5.1 NO. 128A (LOT: 2; STR: 80812) HAROLD STREET, MOUNT LAWLEY - PROPOSED ALTERATIONS AND ADDITIONS TO GROUPED DWELLING**Ward:** South**Attachments:**

To consider an application for development approval for alterations and additions to an existing grouped dwelling at No. 128A Harold Street, Mount Lawley (the subject site).

The application proposes to extend the first floor of the dwelling over the existing garage at the rear in order to construct a new terrace addition with a deck and a pool.

Boundary Wall to North West

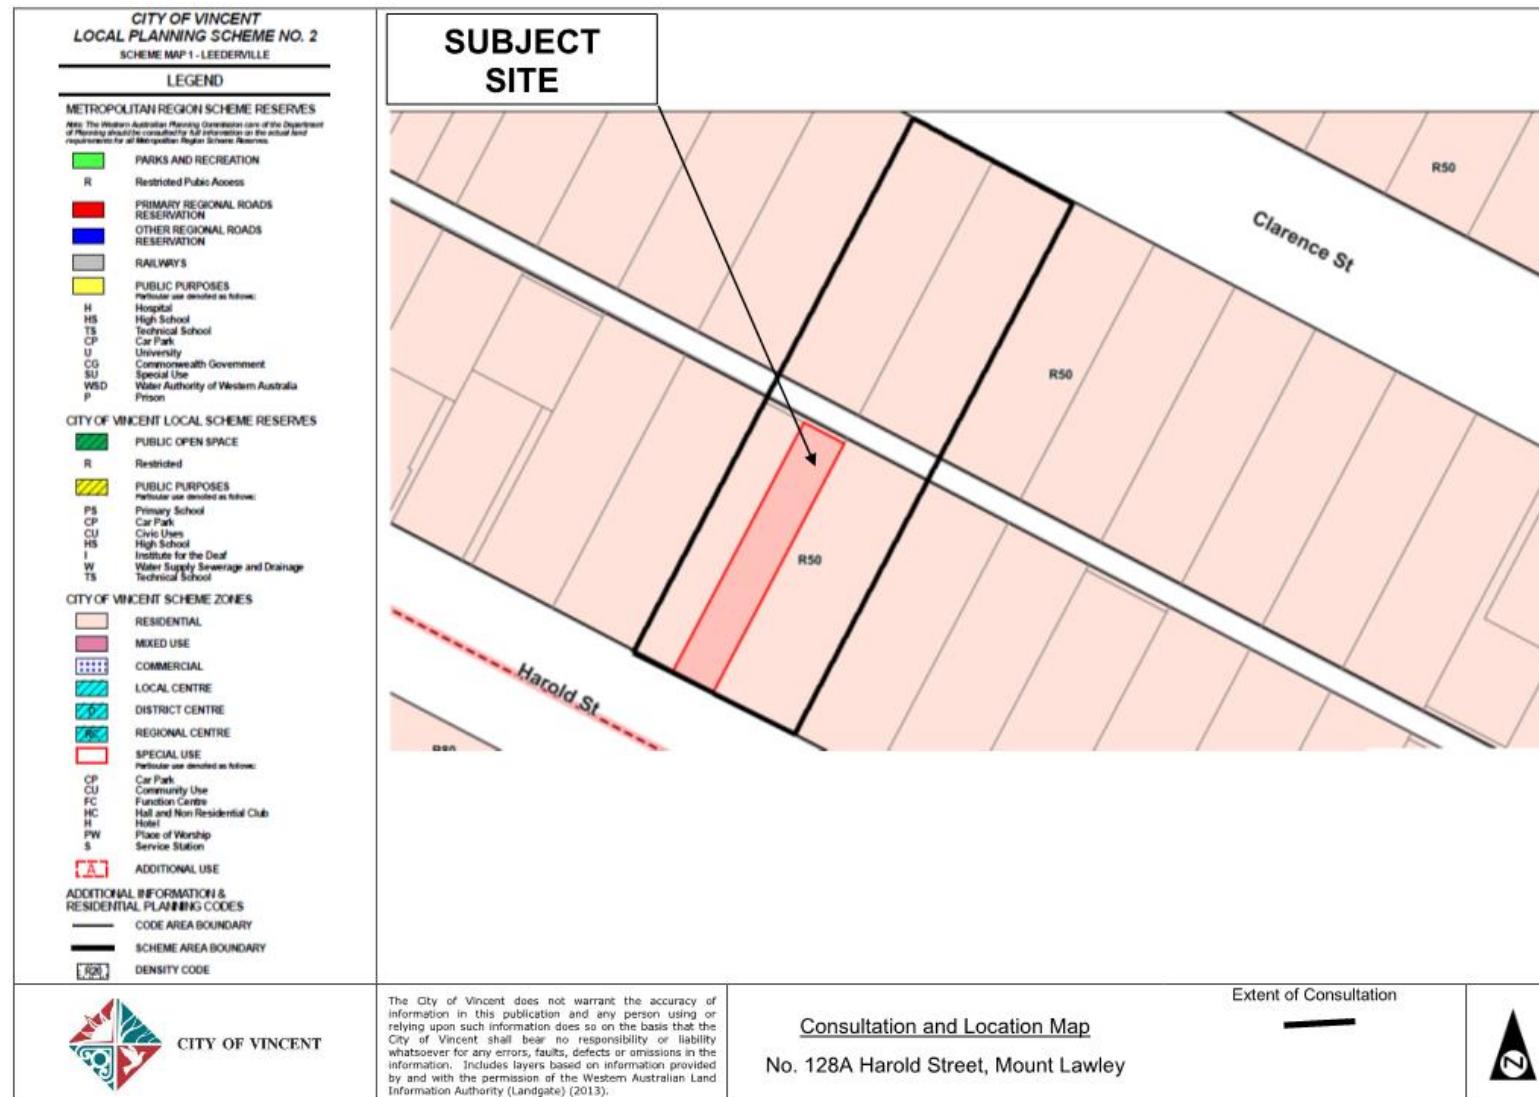
The R Codes deemed to comply standard permits boundary walls to two sides with a height of 3.5 metres and length of 22.2 metres, being two thirds of the lot boundary behind the front setback.

The privacy screen proposed to the north west of the first floor terrace is 7.6 metres in length and 1.3 metres in height and would be on top of an existing parapet wall. The proposed privacy screen to the first floor terrace would extend the existing boundary wall along the north western lot boundary by 7.6 metres to a total boundary wall length of 31.3 metres. The proposed privacy screen would also result in a 1.3 metre increase to the existing boundary wall height for this portion of the boundary to a height of 6.1 metres.

The proposed boundary wall extension satisfies the design principles of the R Codes and local housing objectives of the Built Form Policy for the following reasons:

- Mitigating Building Bulk:
 - The boundary wall extension would abut the garage of the adjoining property to the north-west. This would limit the impact associated with building bulk, as this area is void of any habitable rooms and living spaces; and

- The proposed increase of 1.3 metres in height of the existing boundary wall would be due to the installation of aluminium privacy screening. The screen would be of varying material and colour to the existing parapet wall that would assist with breaking up the mass, reducing the appearance of blank walls and creating visual interest.
